Transport for Tomorrow

Heavy Vehicle Local Road Report for Use of Local Roads

| Project | Sydney Metro – Western Sydney Airport Enabling Works |
| Revision Date | 15 th July 2022 |

INFORMATION DOCUMENT
D0081-DRG-CS-01-1106 [ID]

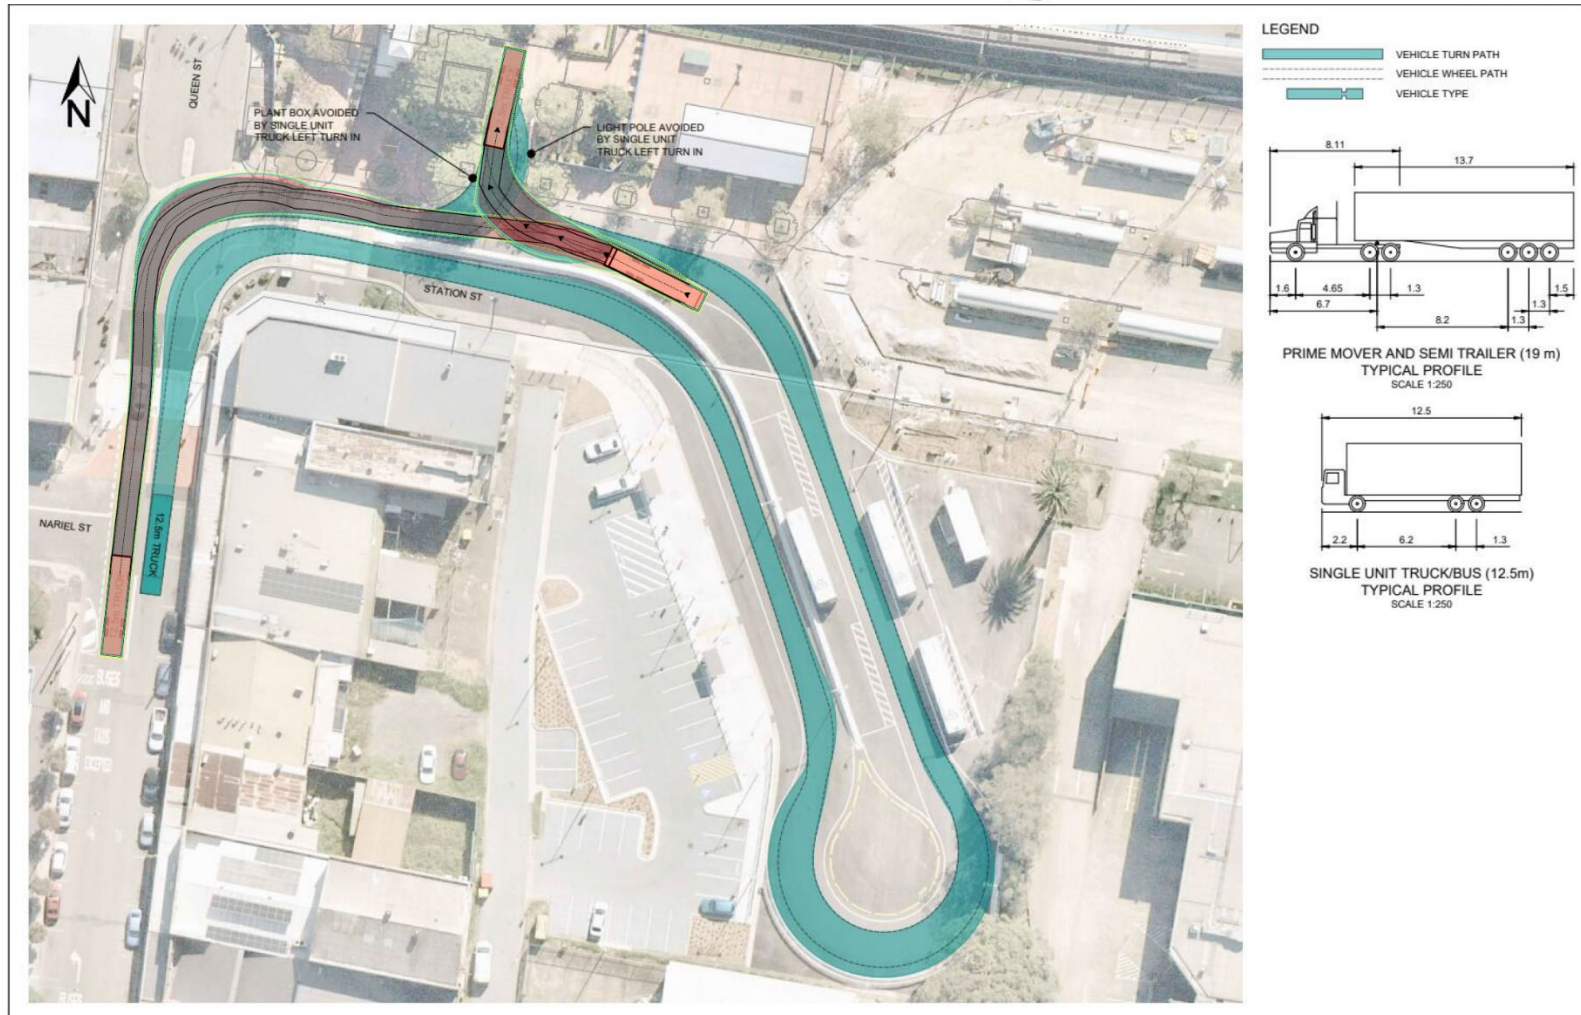
Regarding the 2nd comment, the swept paths have to be updated to show HV reverse manoeuvres so it will be consistent with their response (*HR vehicles may not be able to turn around within the site to exit in a forward direction*). Currently the swept paths provided show HV entering and exiting the site in a forward direction which is misleading.

- Page 15: swept paths show that 12.5m HRV entering and exiting the site in forward direction. However, no swept paths provided to demonstrate that the HRV can turn around within the site. –
It is acknowledged that HR vehicles may not be able to turn around within the site to exit in a forward direction. In accordance with the approved CTMP for this site, Traffic Controllers will be present at all times to manage HV movements. The associated TGS has been attached as part of this response. No further swept paths are required.

- Swept paths must show 500mm clearance on both sides of the vehicle and demonstrate that the clearance lines are clear of kerbs/obstructions/opposite traffic flow.
- Page 15: swept paths show that 12.5m HRV entering and exiting the site in forward direction. However, no swept paths provided to demonstrate that the HRV can turn around within the site.
- Page 20-21: Show westbound trucks straddling between 2 lanes instead of using the right lane when turning left to Glossop Street. This is to prevent other vehicles from using the left lane (truck's blind spot) at the same time with the truck.

Based on the remaining comment Hamish had on the HVLR document below which was just to show reversing sweep paths, the attached diagram provided is deemed acceptable to make consistent with the HVLR report. Can please send through an updated HVLR with the updated plan incorporated.

Please see attached updated swept path as requested by Hamish yesterday. This was the final comment to close out.

**PHILLIP ST / GLOSSOP ST
SINGLE UNIT TRUCK
TURN PATH PLAN**

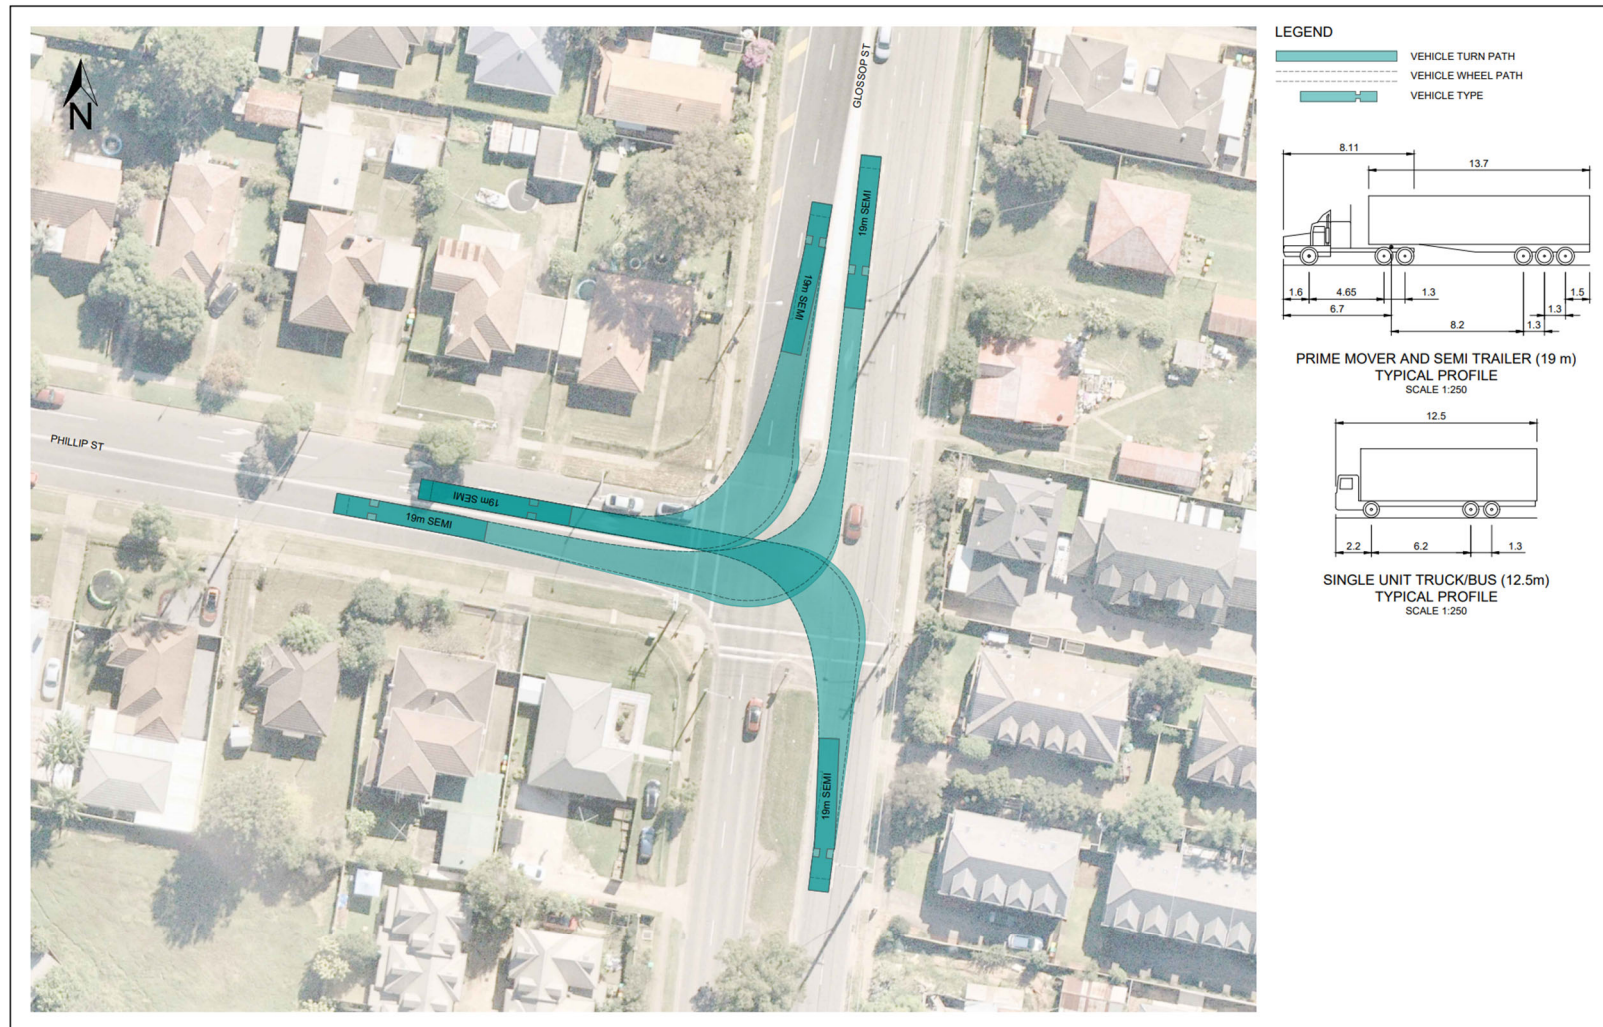
- Page 20-21: Show westbound trucks straddling between 2 lanes instead of using the right lane when turning left to Glossop Street. This is to prevent other vehicles from using the left lane (truck's blind spot) at the same time with the truck. –

12.5m vehicle fine, but 19m semi this is not required as such size vehicles are permitted to make required turn from said lane. Straddling lane would pose risk on kerb mounting and possible pedestrian interface.
